This Service Information bulletin replaces SI B33 03 15 **dated October 2015**

F85 – X5M

F86 – X6M

There is an oil leak from the rear differential housing.

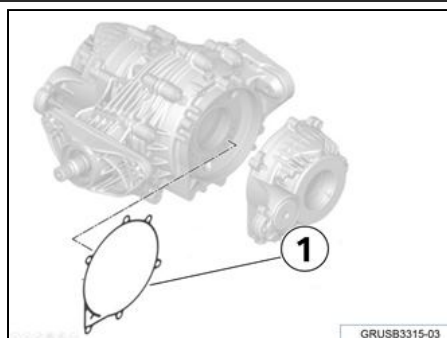
The liquid-type sealer used between the main differential housing and the outer superimposing gear units has failed.

Replace the gaskets between the superimposing gear cases and the main differential housing.

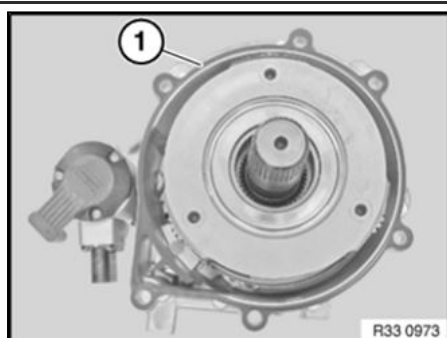
Gaskets are available through EPC (PN 33 10 7 601 264) for resealing the superimposing gear cases to the main differential housing (1)

Both halves of the QMVH (1) will need to be resealed during the repair (do not repair only the side that is leaking).

Refer to the Repair Instruction **33 11 694 Overview of rear axle final drive (Dynamic Performance Control)** for complete resealing instructions.
